# **Poolbeg Incinerator**

### **A Critique of the Poolbeg 3 Model**

Notes to accompany PowerPoint presentation

**Joe McCarthy and Valerie Jennings**  
**August 2007**

### Capacity diagram

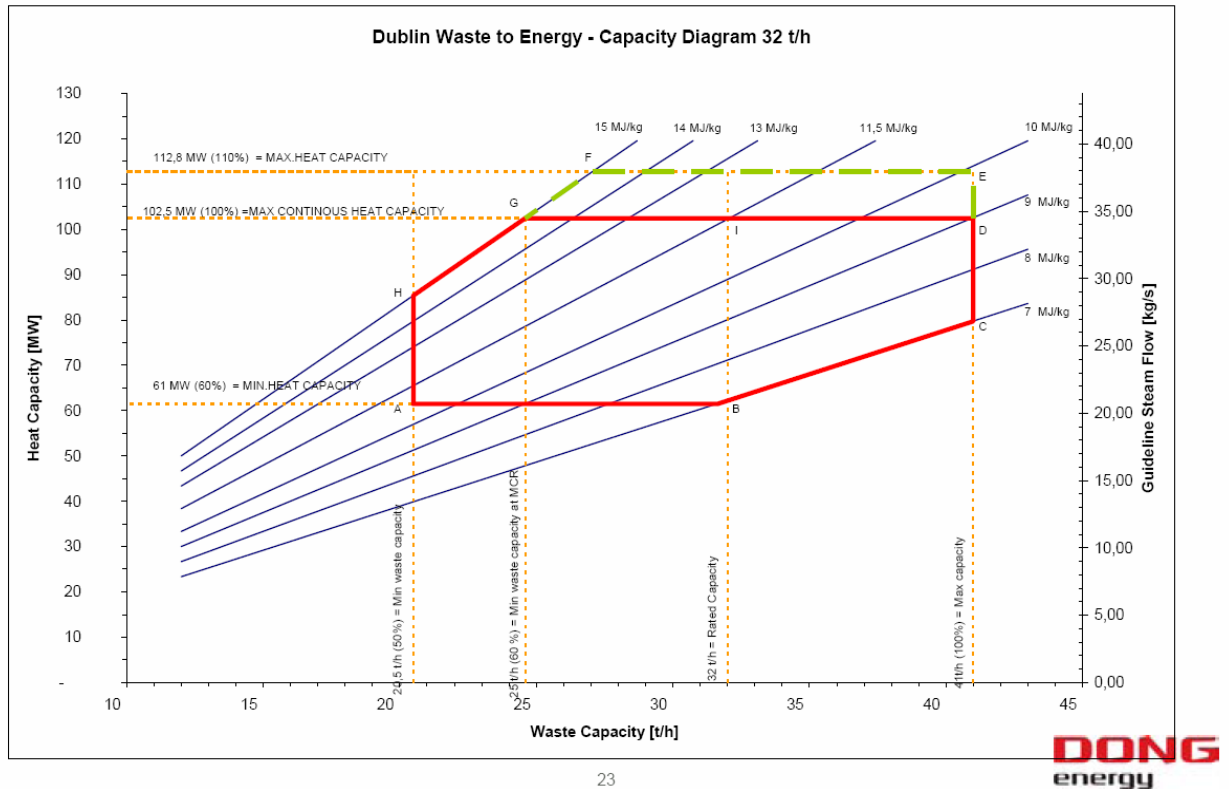
We carefully examined the capacity diagram which was presented by Mr Norgaard and we quizzed him on the physical capacity of his design.

He confirmed that the capacity diagram shows the maximum heat out put of the boiler is 102.5 MW. There are 2 boilers in this plant and therefore 205 MW is the maximum heat available. When this is multiplied by an ambitious efficiency factor of 29% provided by Mr Norgaard the result is 59.45 MW of electricity generated at the turbine.

### Poolbeg 3 – Scenario 1

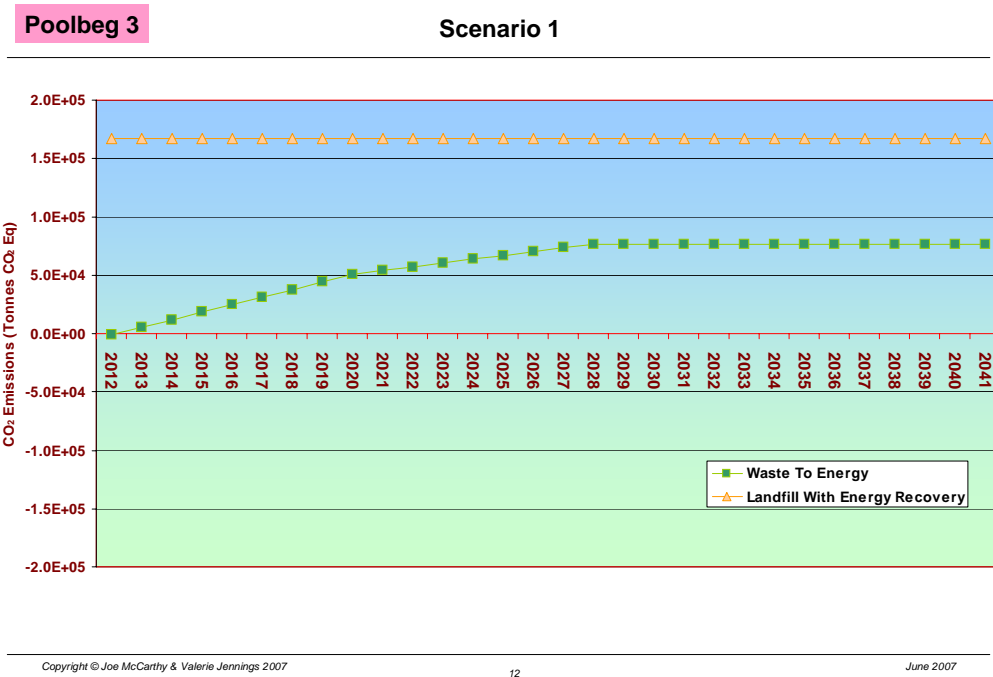
We were able to analyse just one graph because we had the graph for Scenario 1 – this is as published. It shows incineration on the green line as being just barely beneficial in 2012 and then becoming damaging over the period.

Landfill is shown without any calculation of the effects of carbon sequestration.

## Poolbeg 3 – Scenario 1 - Corrected

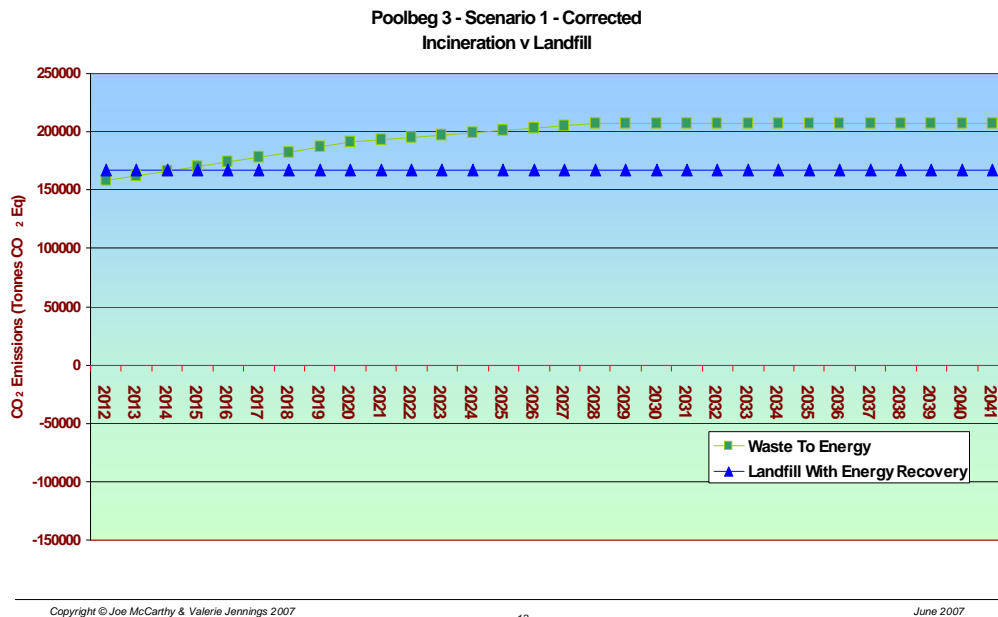
We recalculated Dr Porter's model with the corrections noted above and the difference in the green line for incineration line is significant.

Because Dr Porter omitted carbon sequestration in his Poolbeg 3 Model we were unable to run any comparison on this aspect.

This is a significant omission by him.
